**MAINE TURNPIKE AUTHORITY**

**ADDENDUM NO. 1**

**CONTRACT**  
**2021.02**

**WATER LINE AND UTILITY**  
**VAULTS**

SHEET NUMBER: HP-02  
 CONTRACT: 2021.02  
 12 OF 40

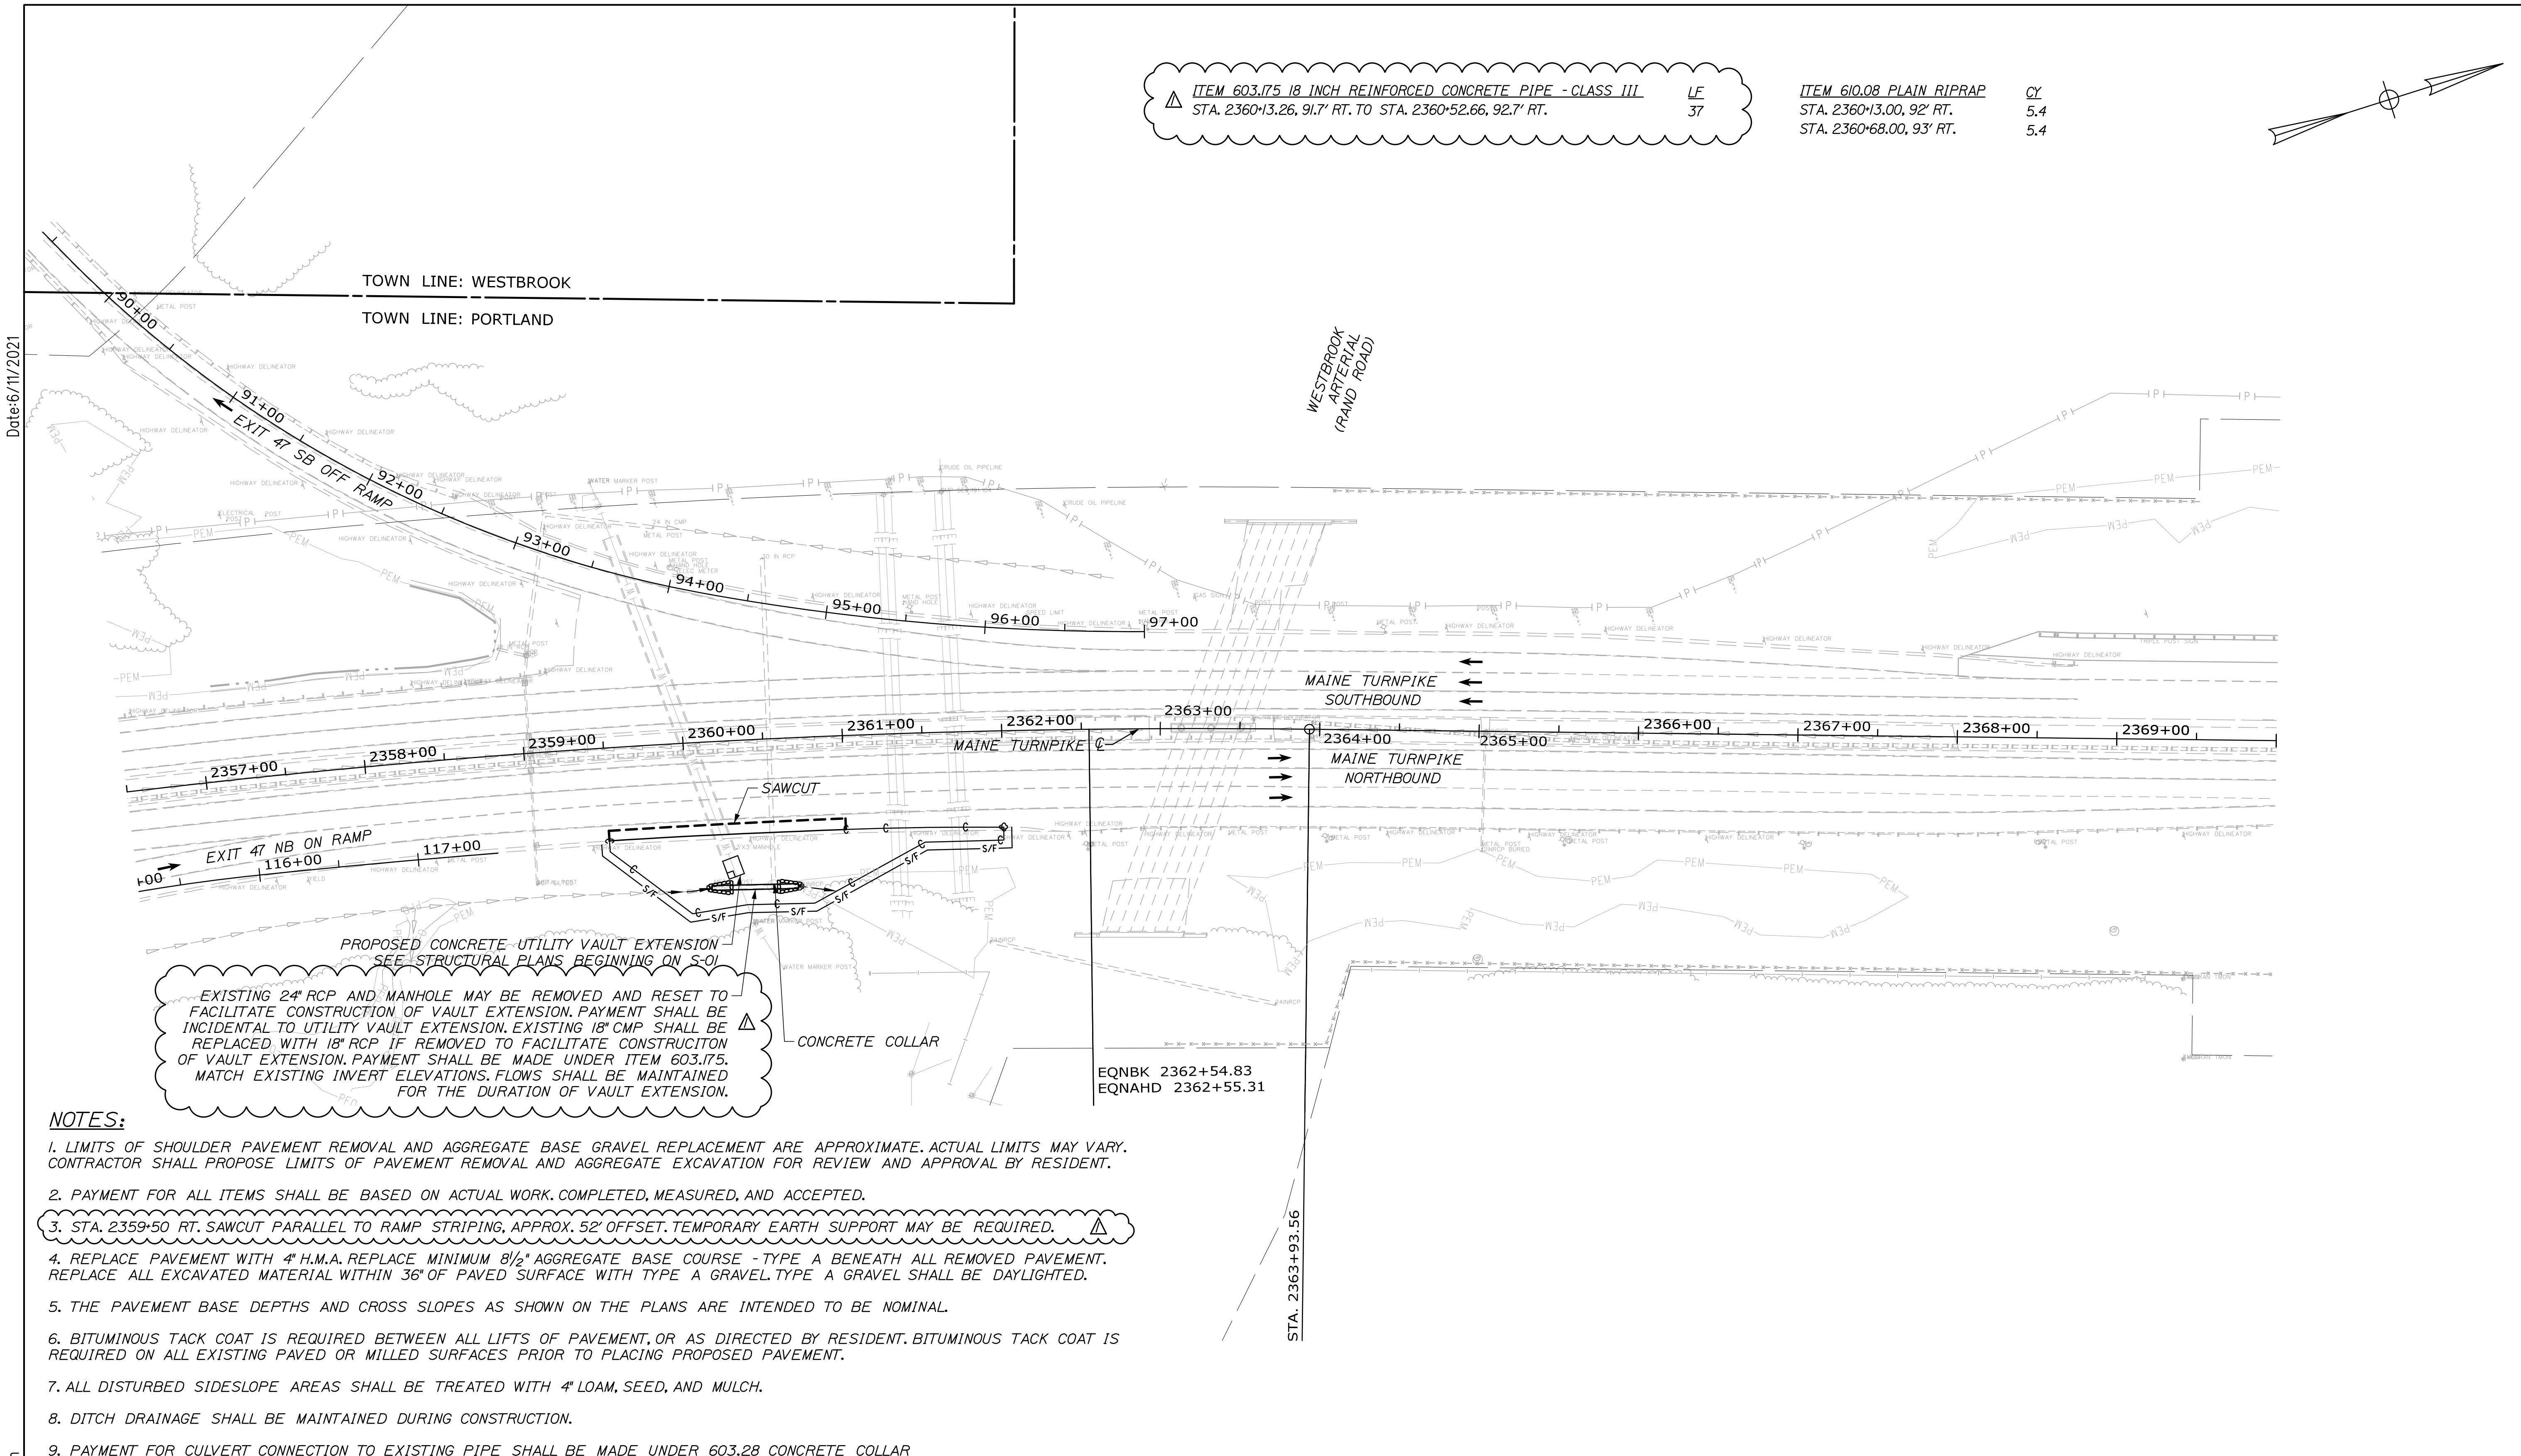
Question 1: There is a drainage manhole adjacent to the Utility Vault at station 2360+02. Does it need to be removed or can we work around it?

ITEM 603.175 18 INCH REINFORCED CONCRETE PIPE - CLASS III LF 37  
 STA. 2360+13.26, 91.7' RT. TO STA. 2360+52.66, 92.7' RT.

EXISTING 24" RCP AND MANHOLE MAY BE REMOVED AND RESET TO FACILITATE CONSTRUCTION OF VAULT EXTENSION. PAYMENT SHALL BE INCIDENTAL TO UTILITY VAULT EXTENSION. EXISTING 18" CMP SHALL BE REPLACED WITH 18" RCP IF REMOVED TO FACILITATE CONSTRUCTION OF VAULT EXTENSION. PAYMENT SHALL BE MADE UNDER ITEM 603.175. MATCH EXISTING INVERT ELEVATIONS. FLOWS SHALL BE MAINTAINED FOR THE DURATION OF VAULT EXTENSION.

Answer: The existing 24" RCP and Manhole may be removed and reset to facilitate construction of vault extension. Payment shall be incidental to Utility Vault Extension. The existing 18" CMP over the waterline shall be replaced with 18" RCP if removed to facilitate construction of vault extension. Payment shall be made under Item 603.175.

MAINE TURNPIKE CROSS SECTIONS  
STA. 2340+50.15 TO STA. 2341+15.66

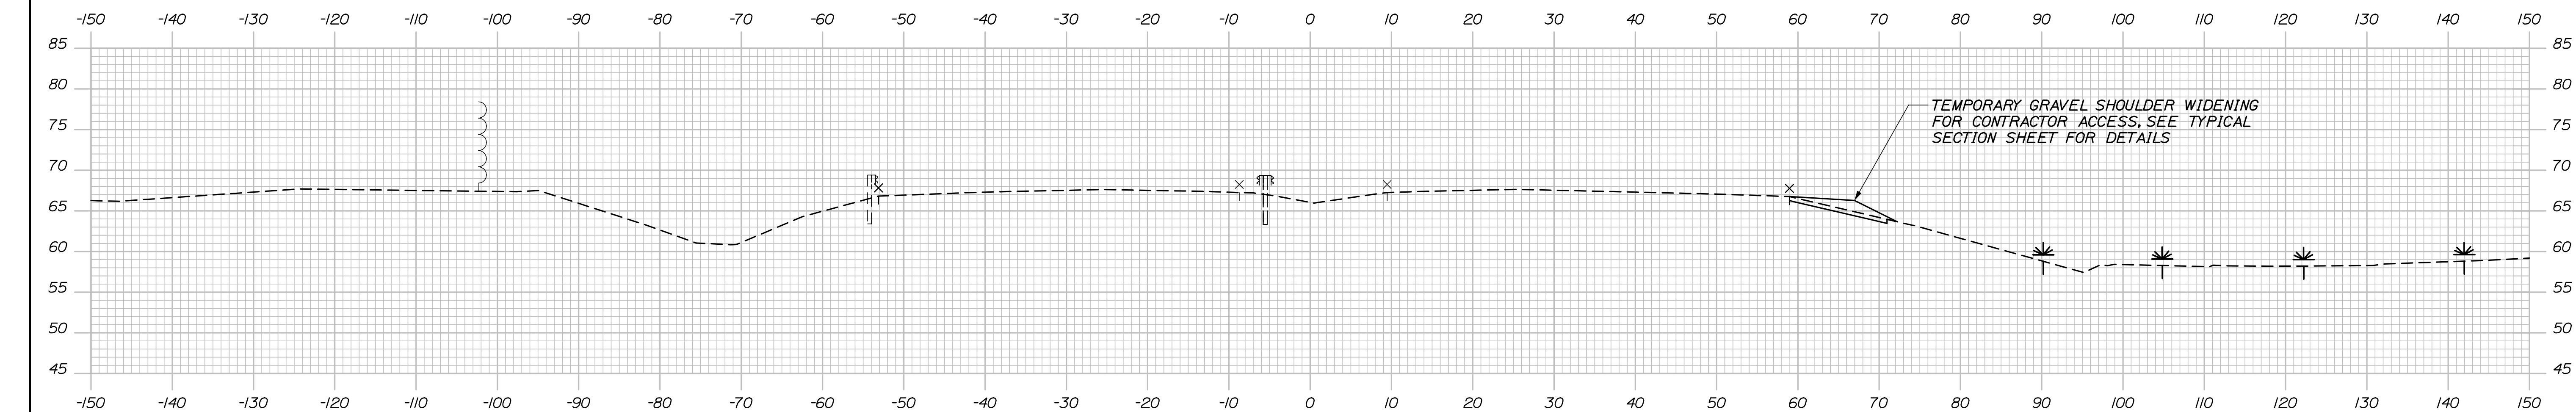
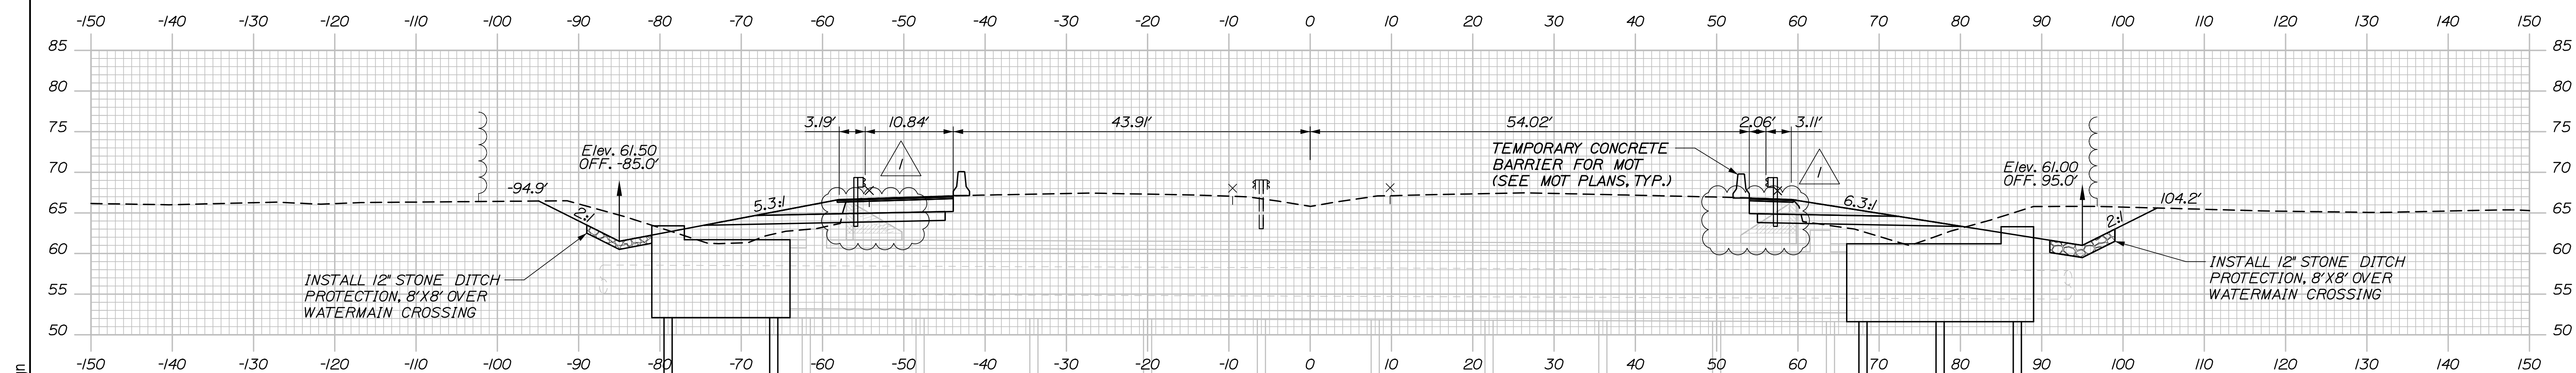
Question 2: The plans show a retaining wall to be removed at one utility vault extension but not the other. Do all existing retaining walls need to be removed?

No.	Revision	By	Date
1	EXISTING RETAINING WALL ADDED	BRG	06/21

Answer: There are retaining walls at the utility vault extension, station 2340+52 northbound and southbound, that shall be removed. See attached structural plans for removal details.

MAINE TURNPIKE CROSS SECTIONS  
STA. 2360+02.55 TO STA. 2360+50

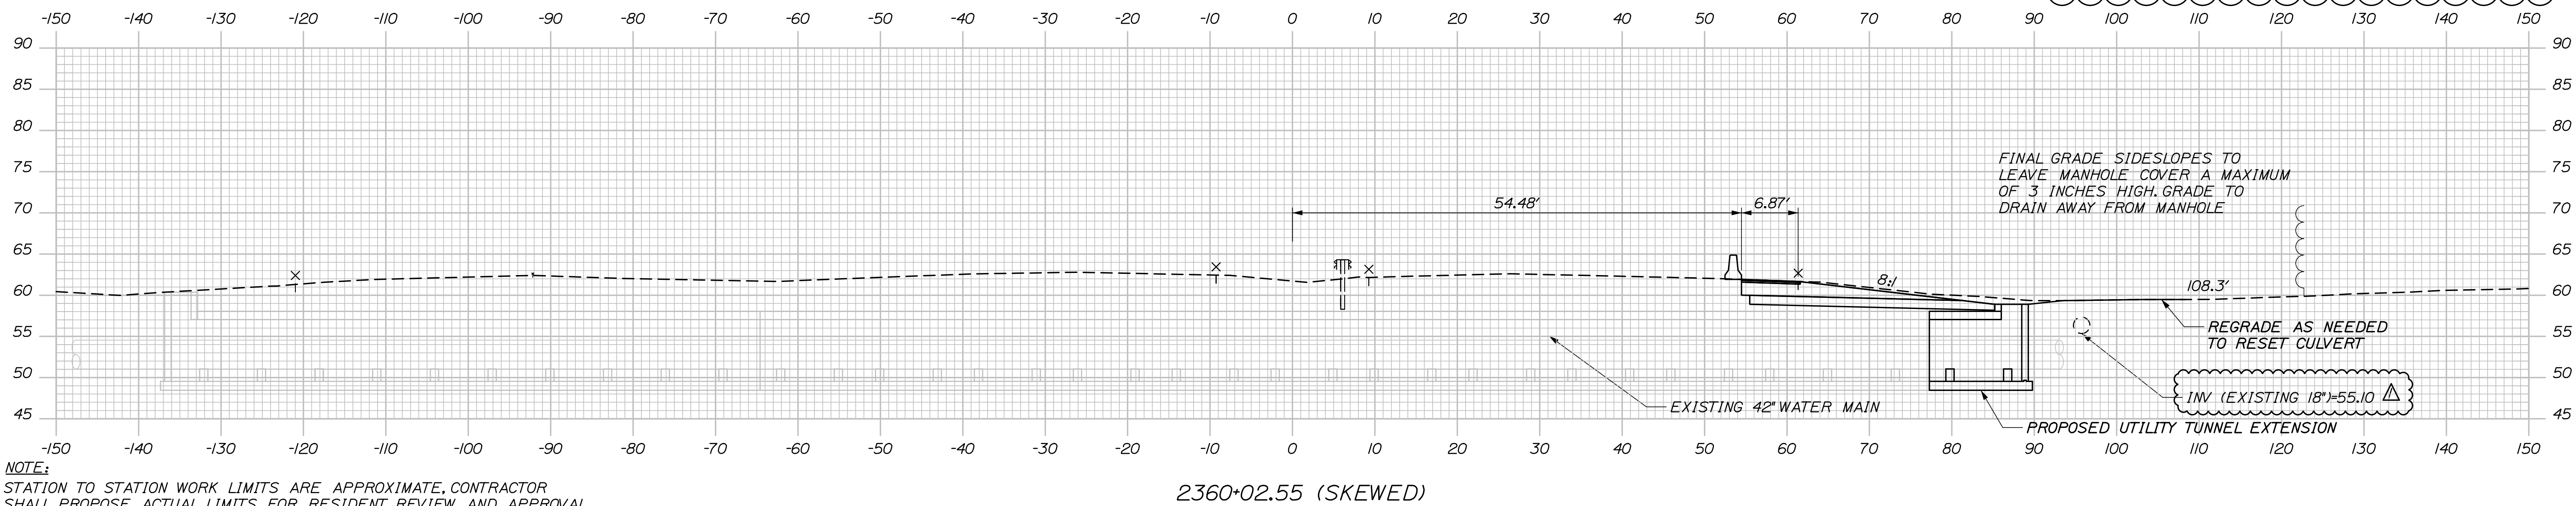
△ EXISTING 24" RCP AND MANHOLE MAY BE REMOVED AND RESET TO FACILITATE CONSTRUCTION OF VAULT EXTENSION. PAYMENT SHALL BE INCIDENTAL TO UTILITY VAULT EXTENSION. EXISTING 18" CMP SHALL BE REPLACED WITH 18" RCP IF REMOVED TO FACILITATE CONSTRUCTION OF VAULT EXTENSION. PAYMENT SHALL BE MADE UNDER ITEM 603.175. MATCH EXISTING INVERT ELEVATIONS. FLOWS SHALL BE MAINTAINED FOR THE DURATION OF VAULT EXTENSION.

PLAN VIEW - UTILITY VAULT

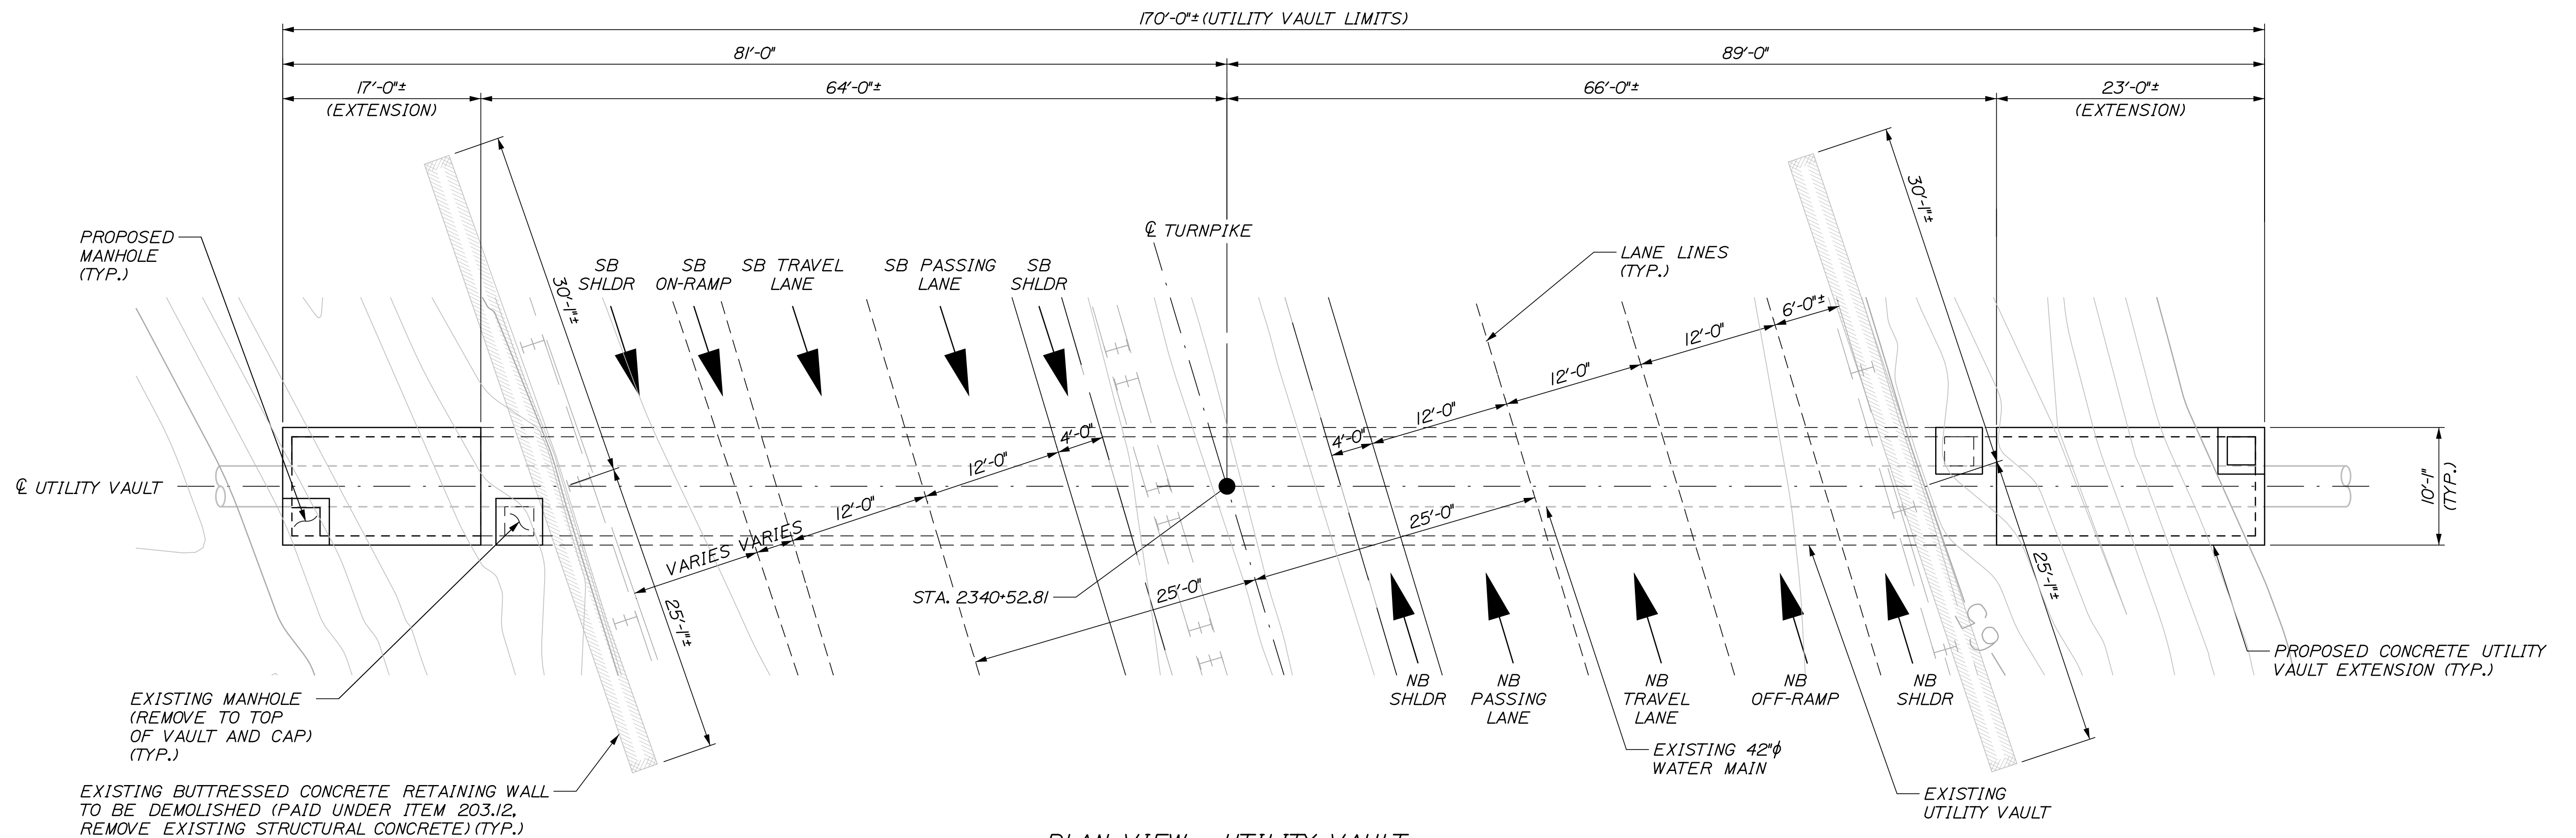
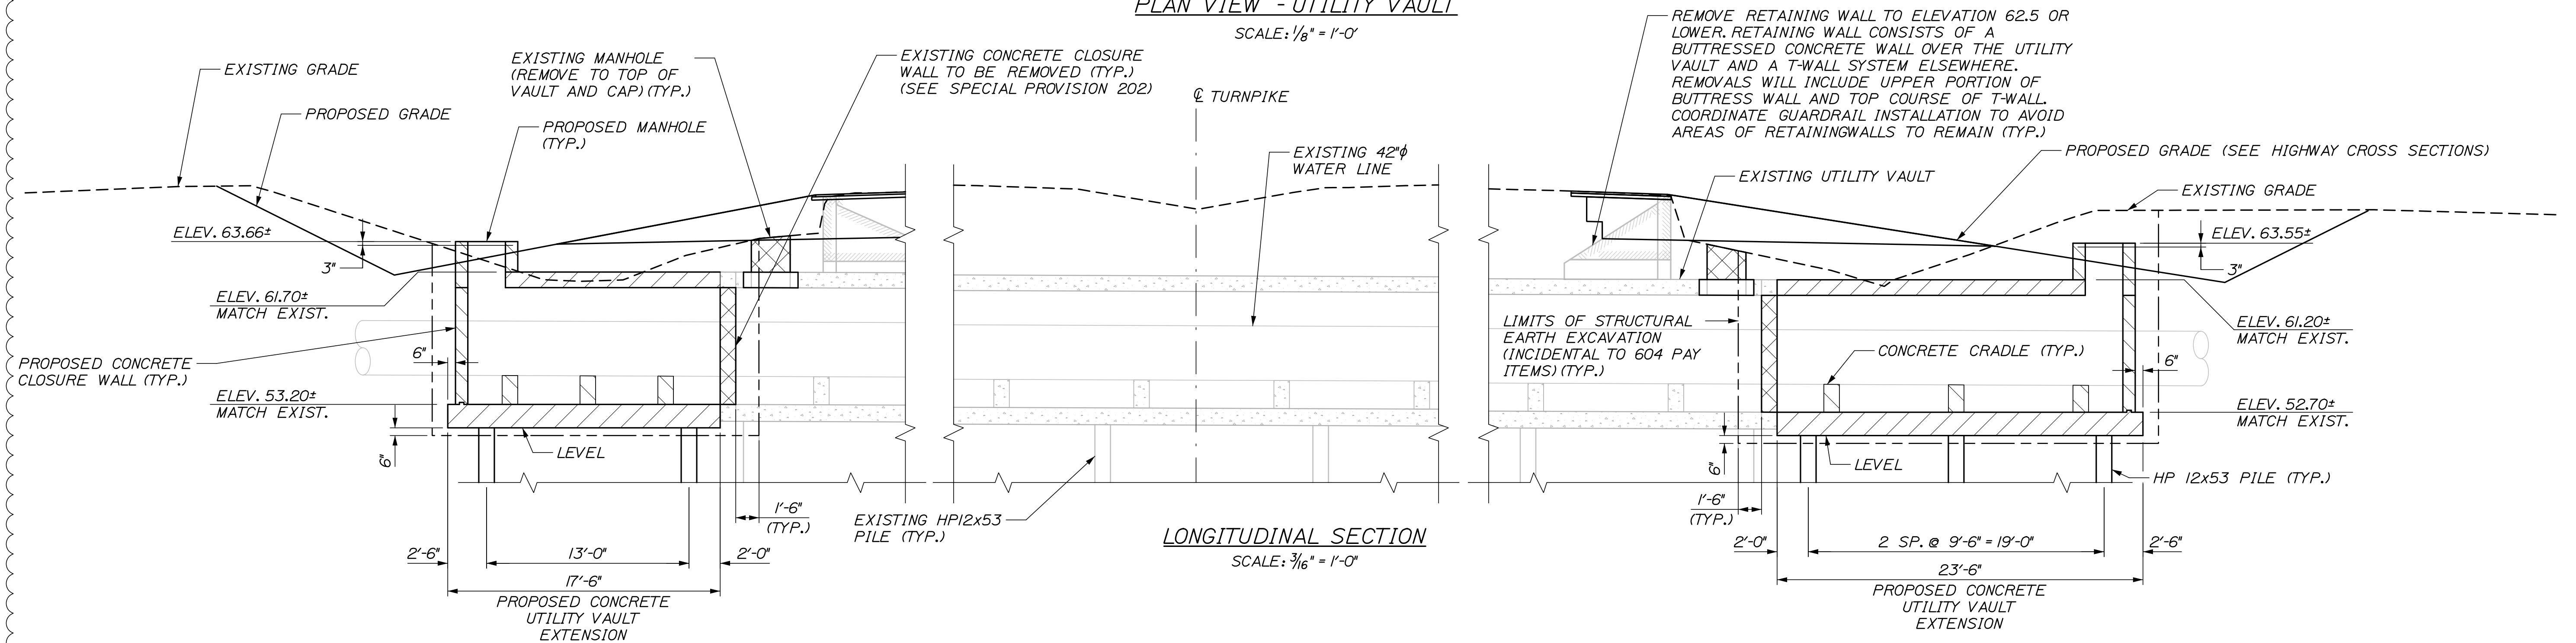
Scale: AS NOTED			
No.	Revision	By	Date
1	ADDED RETAINING WALL DEMOLITION	BRG	06/21
